Pennsylvania Department of Environmental Protection
Response to
Clean Air Task Force Report: “Impacts On Water Quality From
Placement Of Coal Combustion Waste In Pennsylvania Coal Mines”

DEP Bureau of Mining and Reclamation
DEP Bureau of District Mining Operations

November 9, 2007

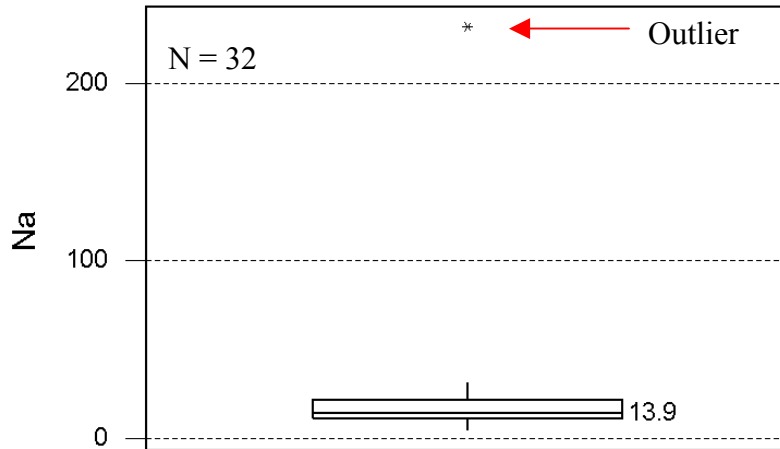
CATF gives undue weight to outlier data. Outliers are data points that are numerically distant from typical values. Fortunately they are infrequent events. Most large sets of water quality data contain outliers. CATF routinely assumes that outliers identify pollution events; this is an invalid assumption. Outliers occur for a lot of reasons including improper sample collection, errors in sample analysis, switching of samples (sample was collected somewhere else), reporting error (such as a decimal error or multiplication by 10), and inclusion of large quantities of suspended matter during sample collection. Typically, outliers are visually obvious, but if they are not evident, there are statistical approaches that can identify outliers (see Figure 2). Another flaw in the logic of citing individual sample events as evidence of degradation is that one must then be equally willing to declare the sampling point improved when the very next sampling event reveals lower concentrations, yet such conclusions are not found in the CATF report. From the Department's experience with mine sites, when pollution events occur they (unfortunately) persist. Pollution at mines is not a one time or infrequent event, but a continuing trend.

Figure 3. Example of one outlier (8/1999) skewing the trend line that is generally flat. There is also an outlier in the pre-ash placement data, which is higher than any post-ash placement value. (Fig. 4.10 from CATF report)

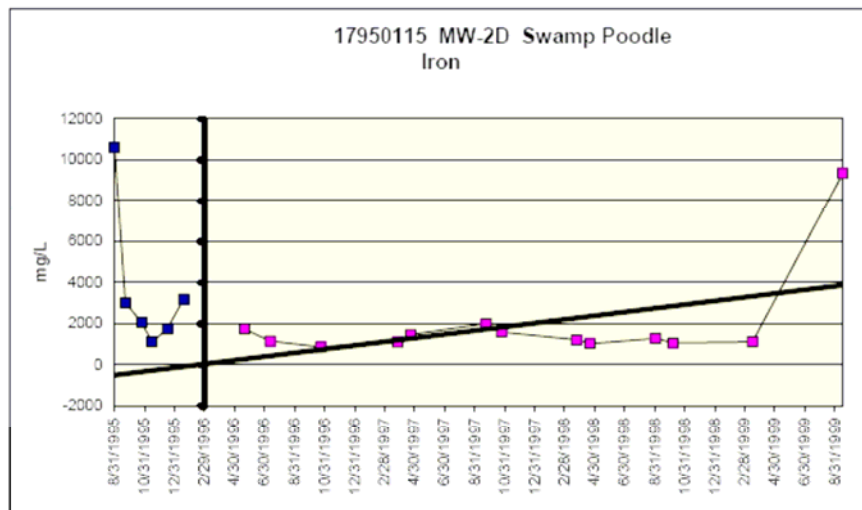
CATF uses statistical trend lines inappropriately. Trend lines are used throughout the report to imply cause-and-effect relationships that often are not otherwise demonstrated nor discussed. Additionally, two CATF interpretation errors are frequently made: (a) Trend lines are placed through data that contains one or two outliers (See example of this in Figure 3). These outlier values, more likely than not being spurious data, are frequently the result of sample collection or analytical error. Placing trend lines through these types of data give outliers undue weight. (b) Trend lines are placed through data that fluctuate widely (Figure 4). These fluctuations are common with mine-impacted waters and are due to seasonal variations and individual precipitation events. Wet times of the year will often result in mine drainage with low concentrations of chemical parameters, or conversely, if a rain event follows a period of drought concentrations can be elevated due to flushing of accumulated pyrite weathering products.

Figure 5. A plot of iron and suspended solids. There is a tendency for samples with high suspended solids to also have high iron. The sample point used here is the “Monitoring Well South” that is monitored for the Ellengowan-Knickerbocker Mine.

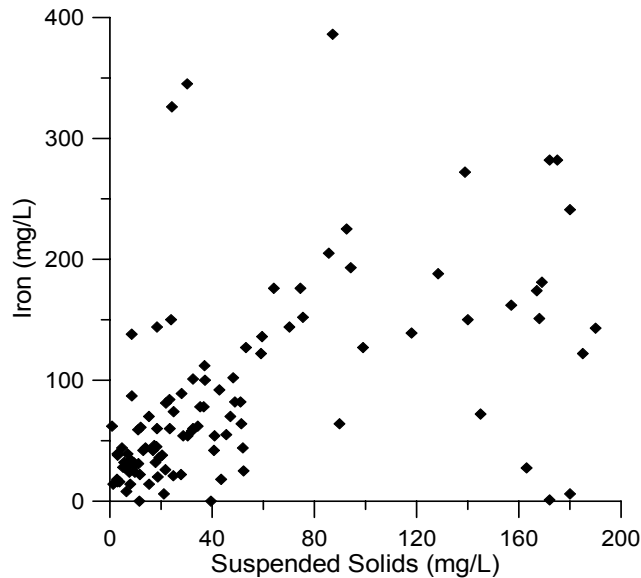
CATF ignores the effects of suspended solids. The CATF fails to recognize the influence of suspended solids on total concentrations of water quality constituents. Suspended solids, as opposed to dissolved solids, is particulate matter that can get dislodged from the sides of monitoring wells or is scooped up during sample collection of discharges. Dissolved solids, on the other hand, are elements that are actually dissolved in the water. Many of the outlier values can be tied to high suspended solids. When samples are collected they are “preserved” in the field with a concentrated acid. This acid will dissolve the suspended particles and if these particles (often just pieces of rock) contain elements being tested, these elements will dissolve into the sample being collected. These elements were not likely to go into solution except under the extreme conditions of the “preserved” sample. Groundwater moves too slowly to contain any appreciable quantity of suspended particles. Thus, high suspended solids in any groundwater sample are a reliable sign that solid material has been dislodged or stirred up during sample collection. The solution to this problem is to require field-filtered samples, which will filter out the suspended particles and give a true reading of the dissolved constituents. The Department is considering making it a requirement to sample ash site for dissolved constituents.

Figure 6. A plot of lead concentration through time at the Ernest site.

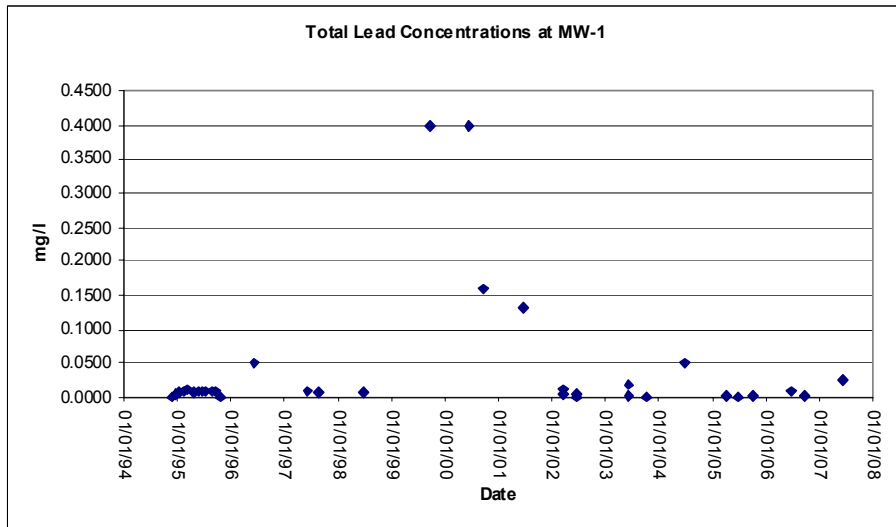
An example of how the CATF and the Department look at the same data and reach different conclusions is illustrated by considering total lead concentrations at monitoring well MW-1 at the Ernest site. On page 57 of its report CATF includes several statements that imply a significant increase in lead at MW-1 over time and state that it "may" be due to ash. On page 65 of the report this alleged increase is characterized as "degradation." The available lead data from MW-1 are graphed in Figure 6. The Department's conclusions regarding the data in Figure 1 include: 1) the abandoned coal refuse at the Ernest site is capable of leaching detectable levels of lead based on the pre-remining (pre-October 1996) data; 2) the high detection limits of 0.40 mg/l reported by the company in the 9-23-99 and 6-16-00 results and of 0.05 mg/l on 6-12-96 and 6-29-04 may not be appropriate, but do not represent actual lead levels; 3) there are detect-

able lead concentrations scattered through the data set; 4) there is no discernible trend in the data that can be accurately characterized as a trend or “degradation.”

Figure 6. Chloride values appear to have increased but values are still far below drinking water secondary MCL values of 250 mg/l. (Figure 5.22a from CATF report)

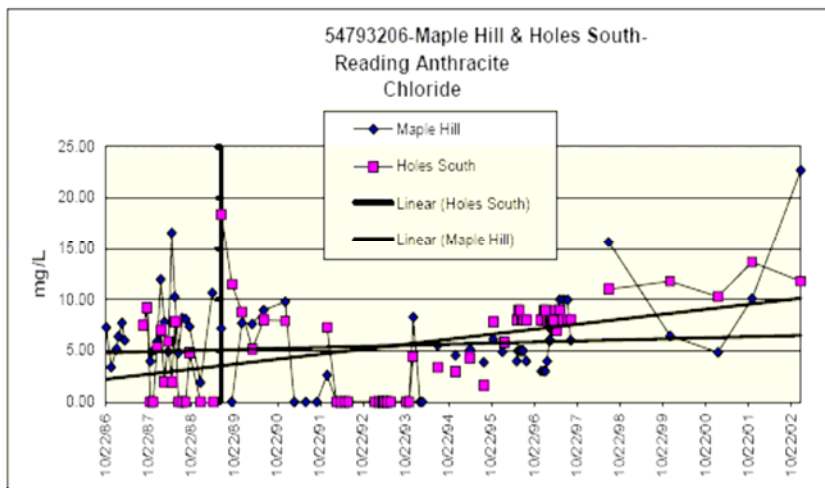
The CATF overemphasizes that parameter 'a' increased 'x' times when in fact the data show concentrations for the element are still quite low. For example, sodium and calcium at Maple Hill & Holes South site (Figure 6) increased over time but remained well below levels routinely consumed in food and drink. There was an increase, but it is inconsequential.

Figure 8. One value causes a clear misrepresentation of a trend. The post-ash data fall mostly below the trend line. Again, the concentrations are inconsequentially low. (Fig. 6.13 from CATF report).

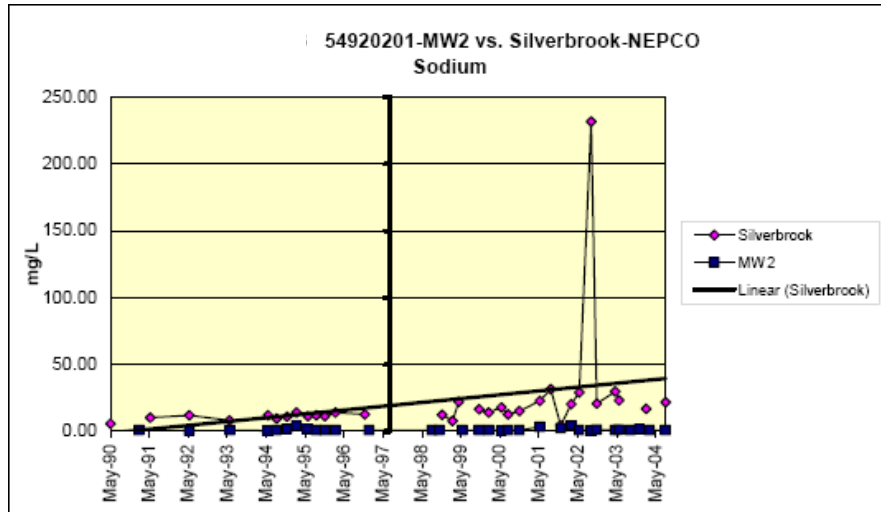
The CATF report contains inappropriate trend lines that project into the past or future where there is no data. Obviously, this is a misleading practice. In the sodium graph, the trend line is highly skewed by one errant sample and becomes a clearly false representation of the data since most of the measured values are contained below it (Figure 8). This errant point is an excellent example of a statistical outlier.

In some cases, the scale is inflated, the values are very small thus portraying the trend as significant where it is not. That is a hallmark of using a graph to lead the viewer towards a conclusion that is, in essence, not self-evident or significant.

Figure 9. The trend line does not realistically represent the behavior of the data. (Fig. 9.3A from CATF report)

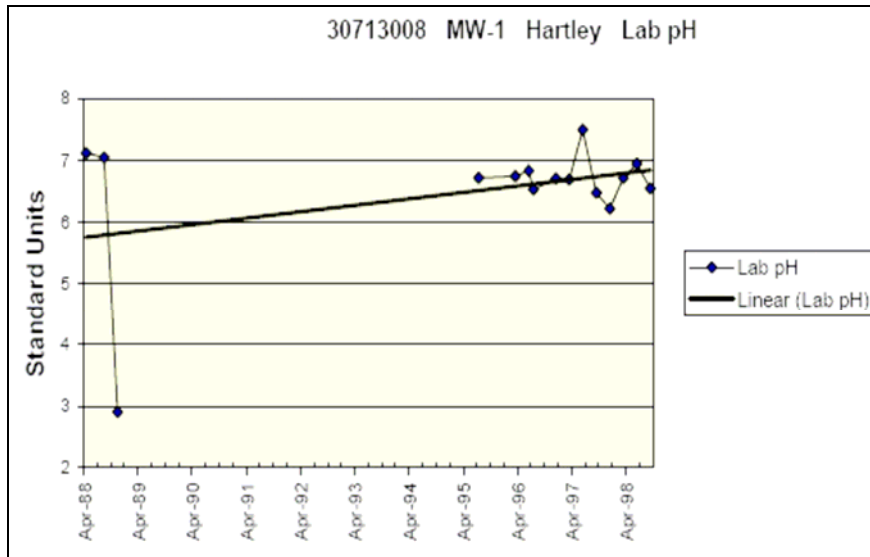
The CATF report does not hesitate to use a lack of data to draw hard conclusions where no data exists. Trend lines are drawn and conclusions are made even though there are wide variations in data or missing data points (see Figure 9). The CATF does not hesitate to use outliers to see problems. The CATF has built its arguments for pollution by making unsupported assumptions and theorized hydrologic connections.

Figure 10. This graph could be interpreted as being three separate parameters increasing through time. However, they essentially measure the same property of the water. (Figure 10.51 of CATF report)

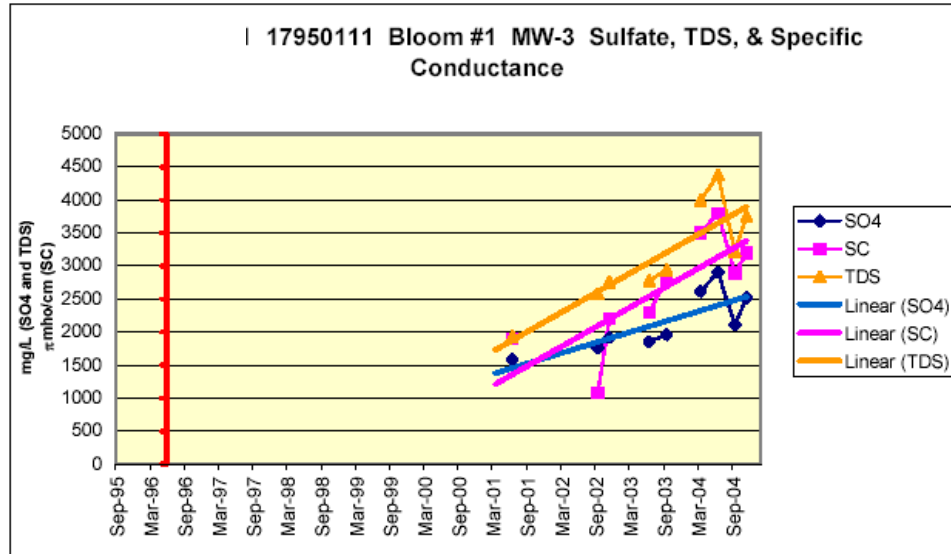
MW-3 is a monitoring well drilled into the backfill of the mine site down to the Middle Kittanning coal seam. The bottom of the well is located 5 feet below the pit floor. The well is cased through the spoil and fly ash so that samples of groundwater within the spoil can be collected. Only one sample has been collected from this monitoring point that included the ash parameters. The elevated parameters are most likely due to high suspended solids within the sample (418 mg/L). High suspended solids at this sample point has been a routine problem at this monitoring point with other samples (samples collected for mine drainage parameters) having 89 mg/L suspended solids or higher for every sample. The data show increasing alkalinity and decreasing acidity, which is attributed to the ash. The elevated sulfate is probably attributable to both the mining and ash placement. Figure 9 shows the increase in sulfate. For those who are unfamiliar with water chemistry, this graph is deceptive: all three parameters plotted on the graph essentially depict the same thing and should look the same. Sulfate is a dominant anion and its concentration would be directly related to total dissolved solids (TDS). Specific conductivity (SC) is simply a way to estimate TDS using an electrode. All three measure the same property.

Elevated concentrations of many constituents are probably due to suspended matter that entered the water during collection and not due to dissolved ions in the water. More samples and filtered samples would resolve the issue of the source of elevated ions.

Figure 11. Chloride and sodium concentrations before and after ash placement. Note that pre-placement values are as high or higher than post-ash placement. All concentrations are low and inconsequential. (Figure 11.11A of CATF report).

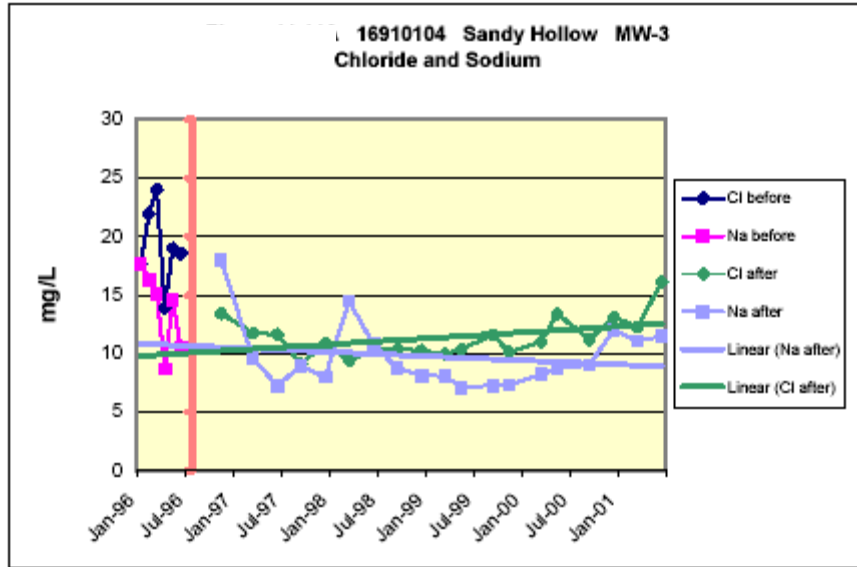
Monitoring data shows that there was an increase in mining-related groundwater parameters that, with the exception of sulfate, returned to pre-mining levels. Chloride and sodium are indicator parameters for FBC ash. The flat lying trend with these parameters (Figure 11) does indicate that there has been no degradation as a result of ash placement on the Sandy Hollow site.
